Proposed amdt to OL/change to tech specs:
consisting of revisions to tech specs with
regard to safety limits for reactor thermal
power and power imbalance combination and
to flux-flow and power-imbalance trip set-
points...(40 cys encl rec'd)

PLANT NAME: Oconee 2 & 3

Re: Oconee Nuclear Station
Docket Nos. 50-270, -287

This letter constitutes Duke Power Company's application for revision of the Oconee Nuclear Station Technical Specifications, pursuant to 10CFR50, §50.90. The proposed revision pertains to Oconee Units 2 and 3 and modifies (i) the safety limits for the reactor thermal power and power imbalance combination and (ii) the Reactor Protection System (RPS) flux-flow and power-imbalance trip setpoints.

Figure 2.3-2B

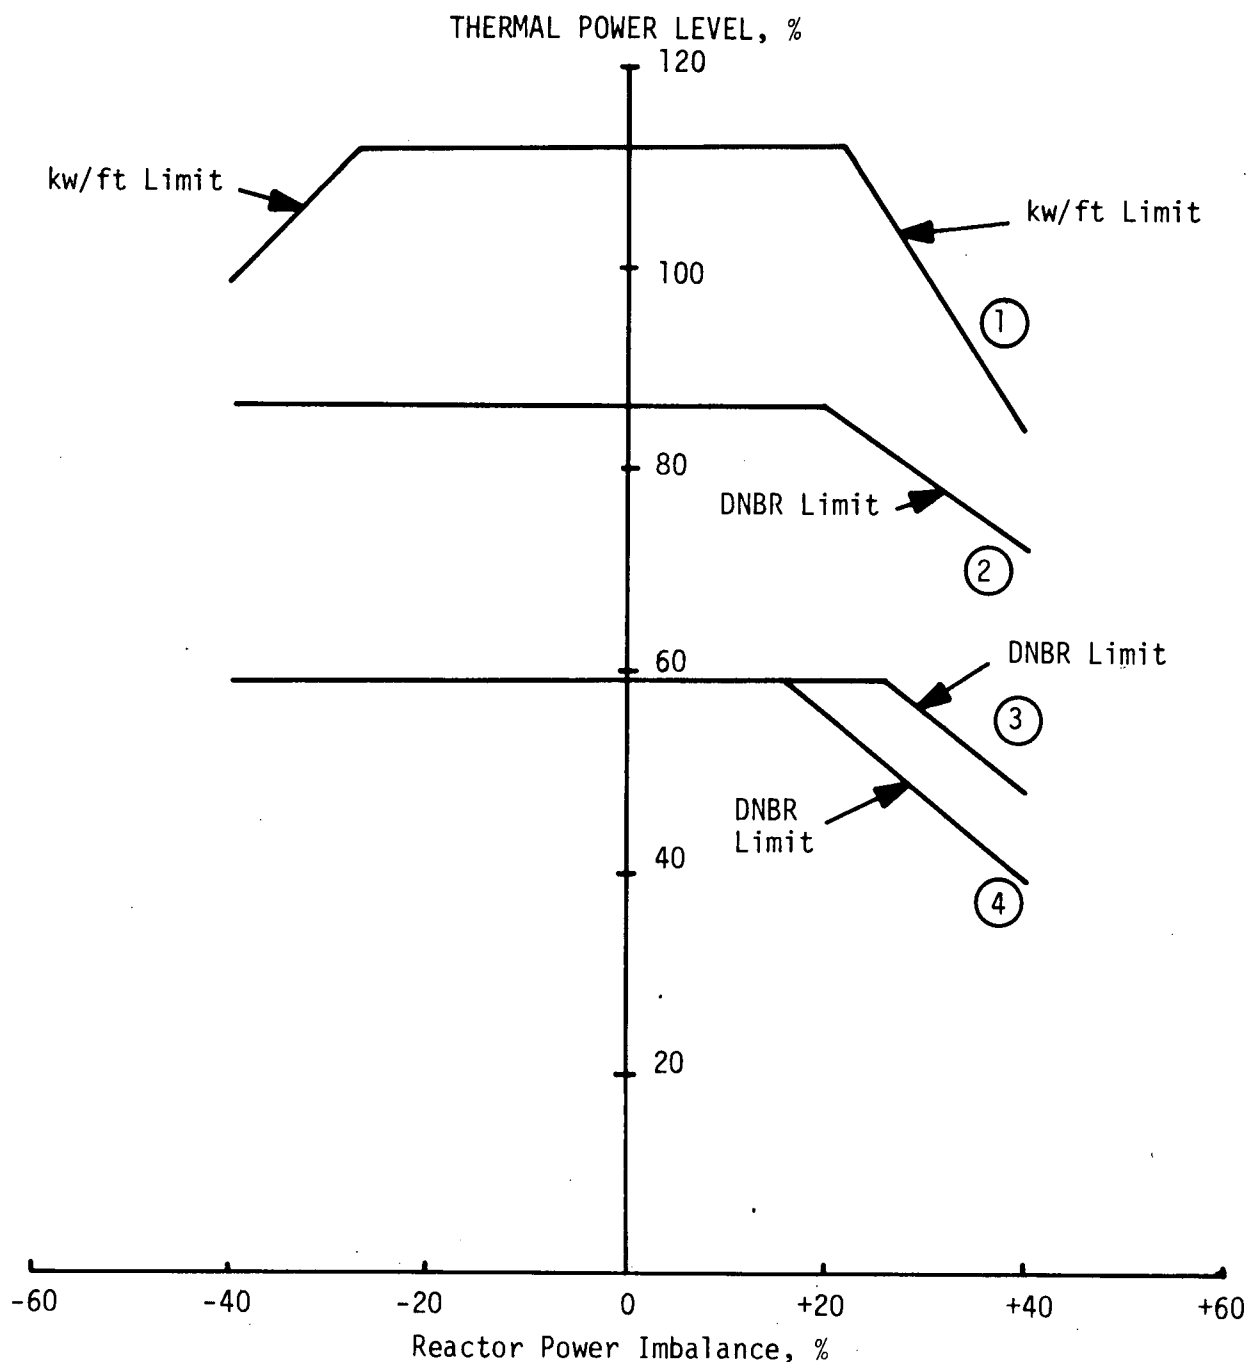
The proposed revision in imbalance limits necessitates a reduction of the flux/flow ratio from 1.07 to 0.961 for single loop operation in order to provide adequate margin from the revised imbalance safety limits.

Figure 2.1-2B

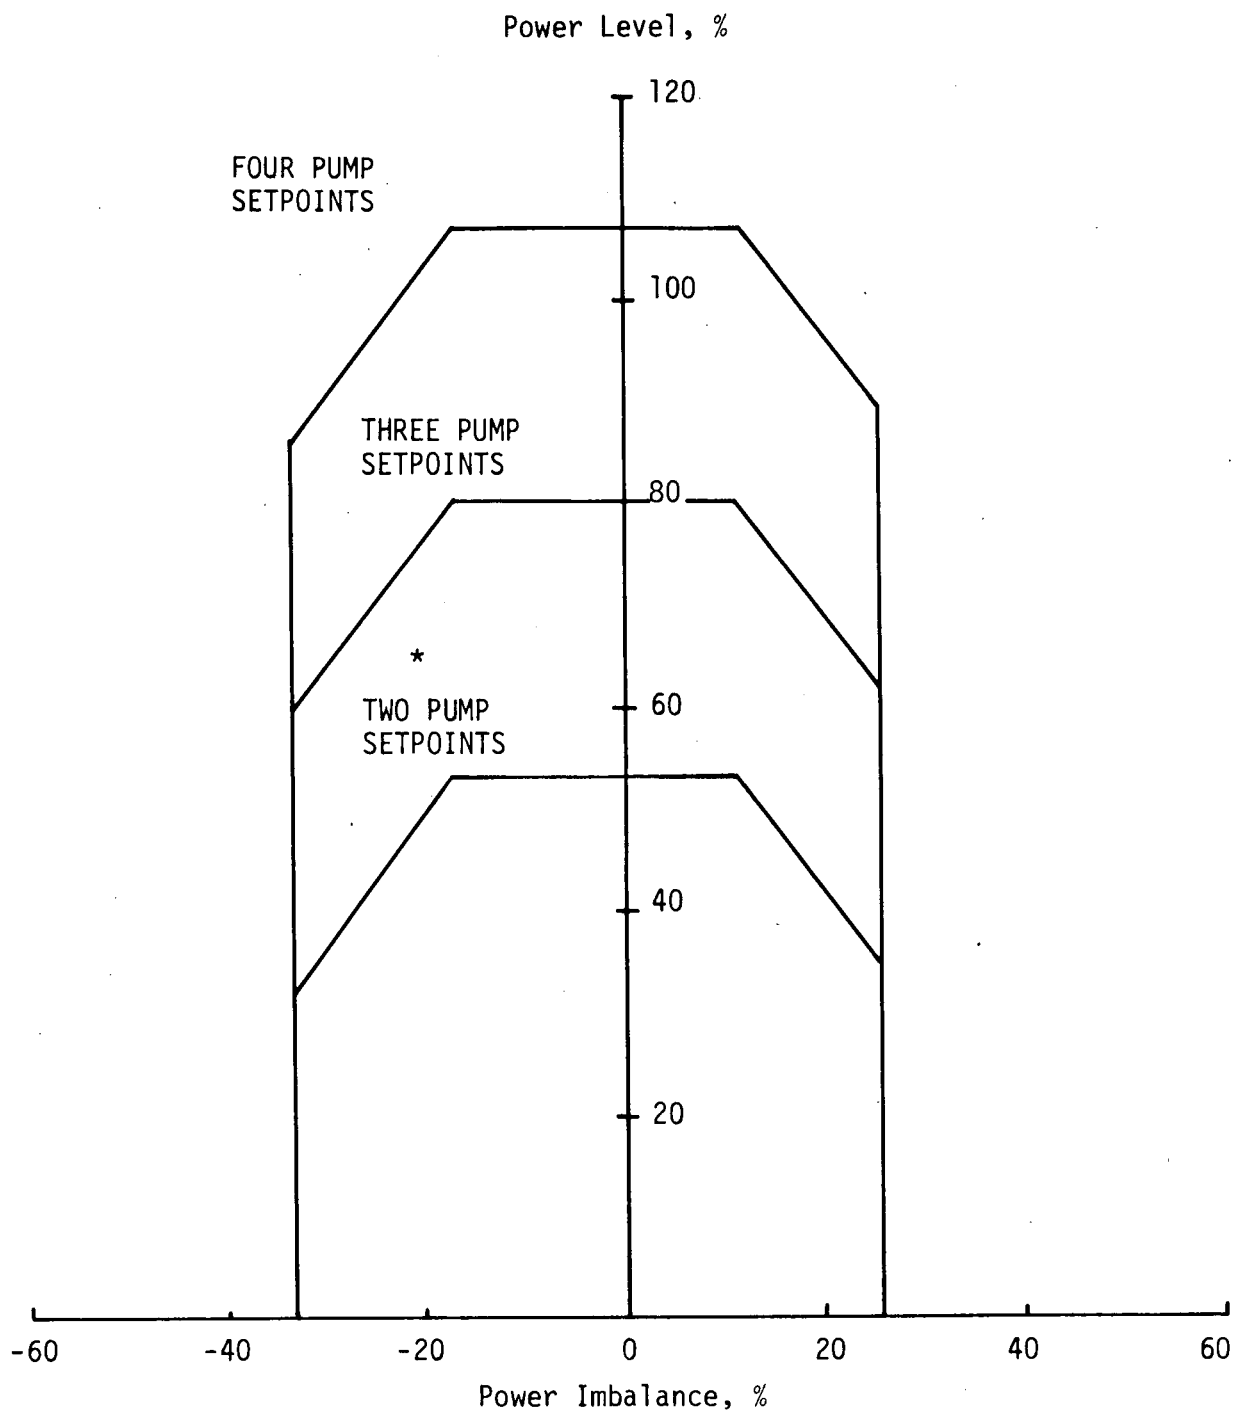
The specified flow rates for Curves 1, 2, 3, and 4 of Figure 2.1-2B correspond to the expected minimum flow rates with four pumps, three pumps, one pump in each loop and two pumps in one loop, respectively.

*For two pumps in one loop, the flux-flow setpoint must be 0.961
